Created: Brandon Baughman	
04/01/2024	
Version: 2.0	
Sheet: 1/1

Safran Project

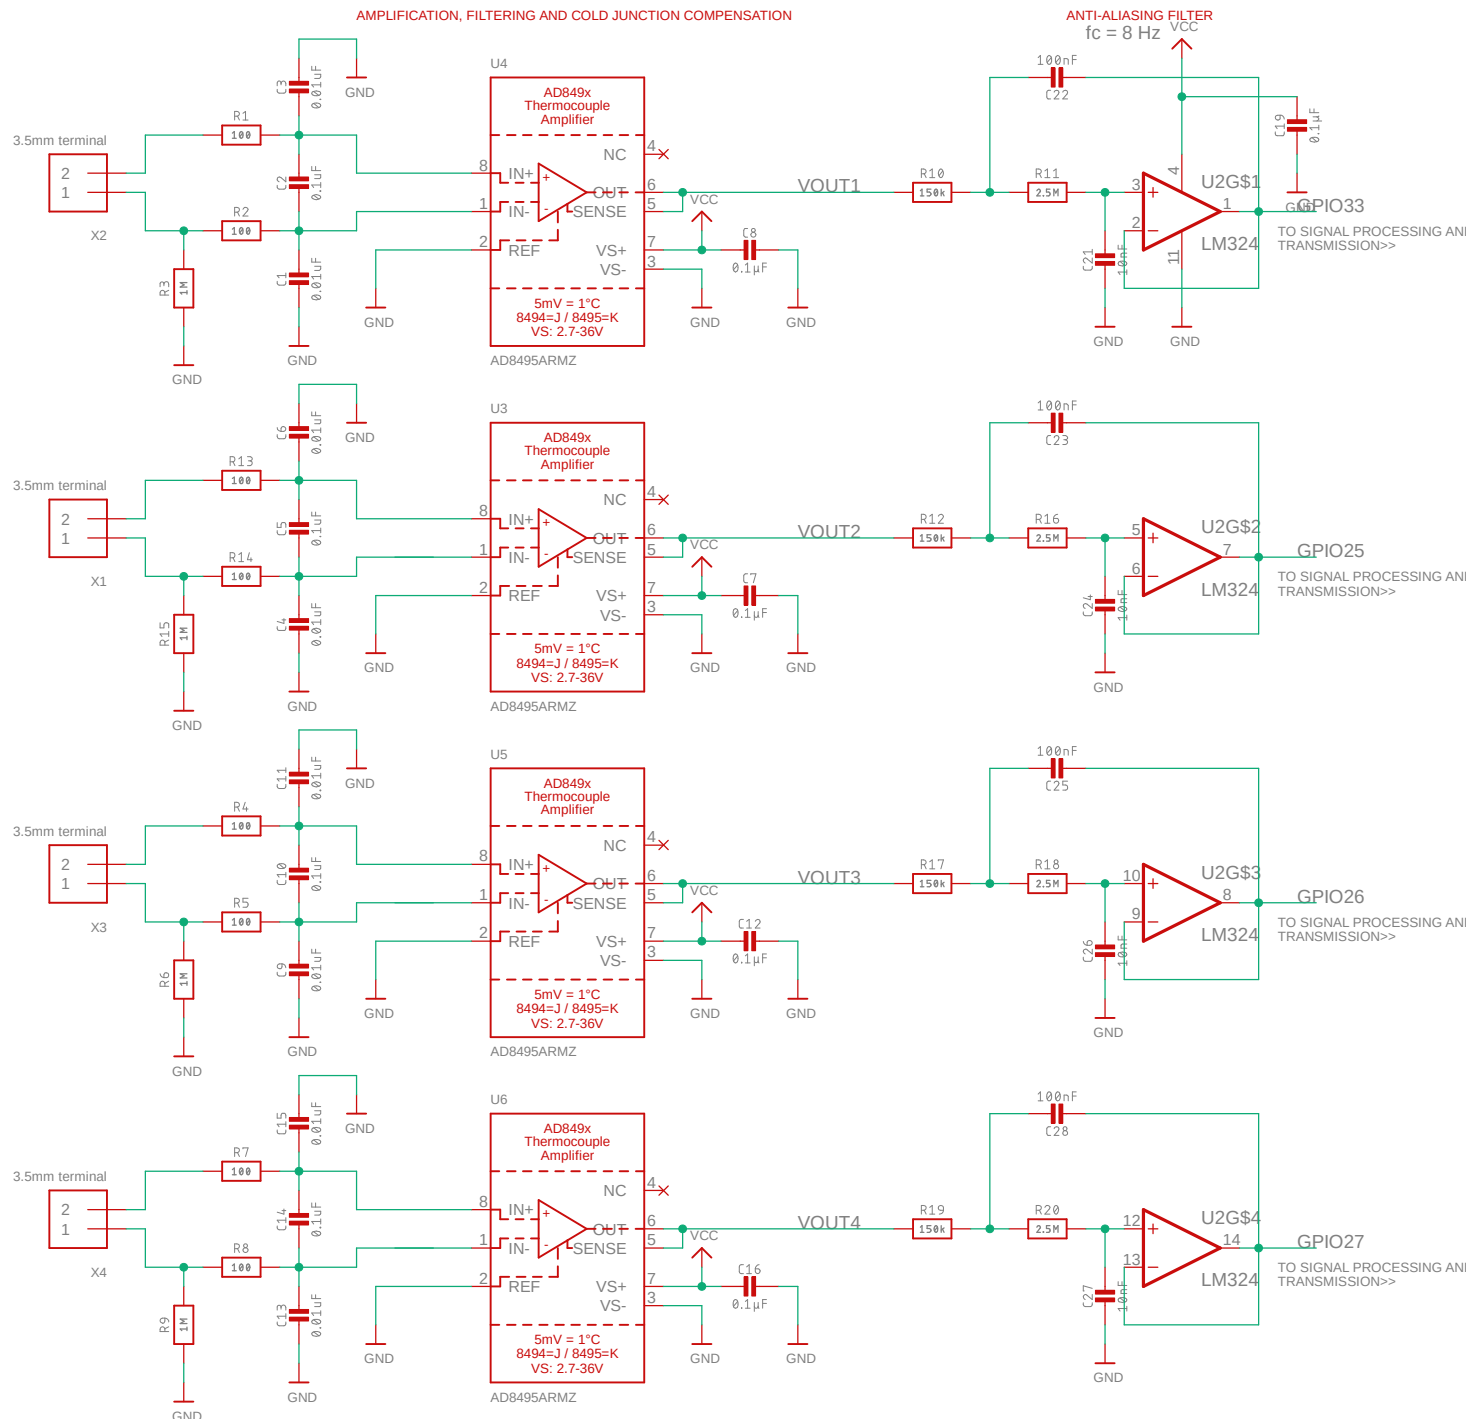
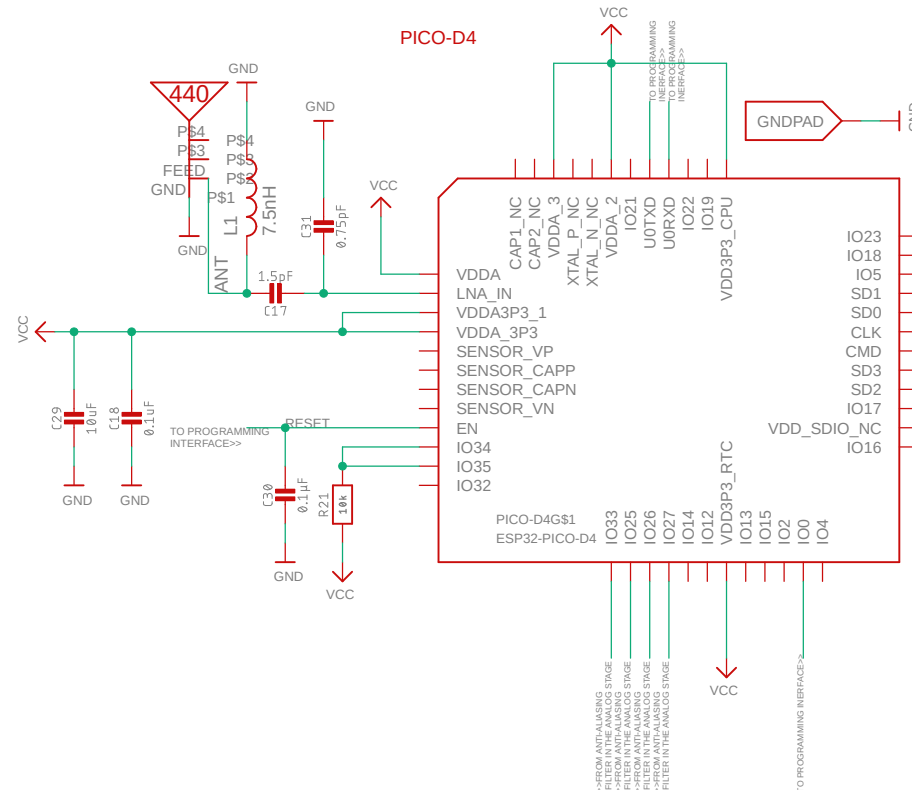
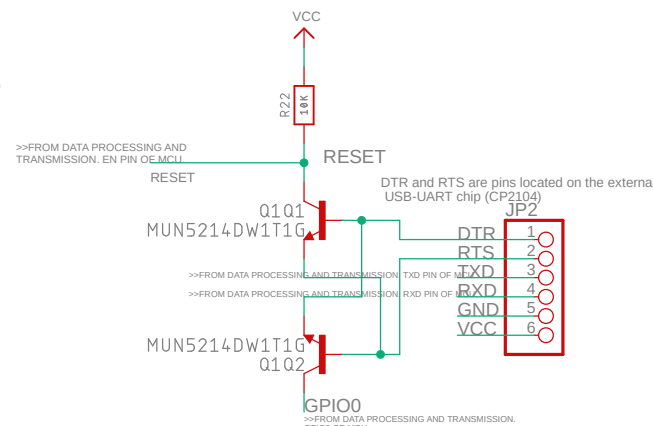
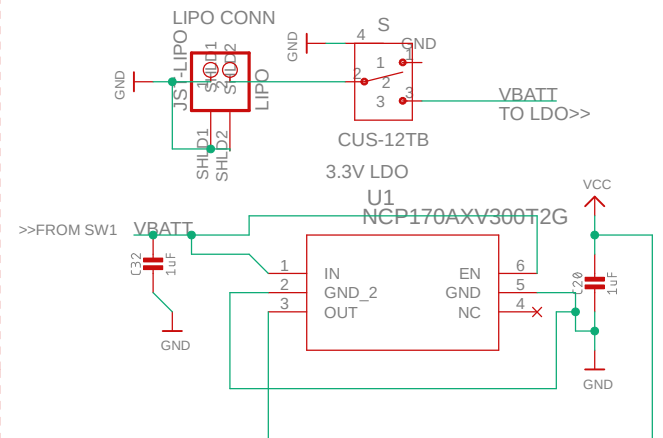
UPDATES:

- BB Inductor L1 package changed to 0805
- BB SW1 changed to CUS-12B
- BB Part NCP170AMX300TCG changed to NCP170AVX300TCG to meet package size requirements.
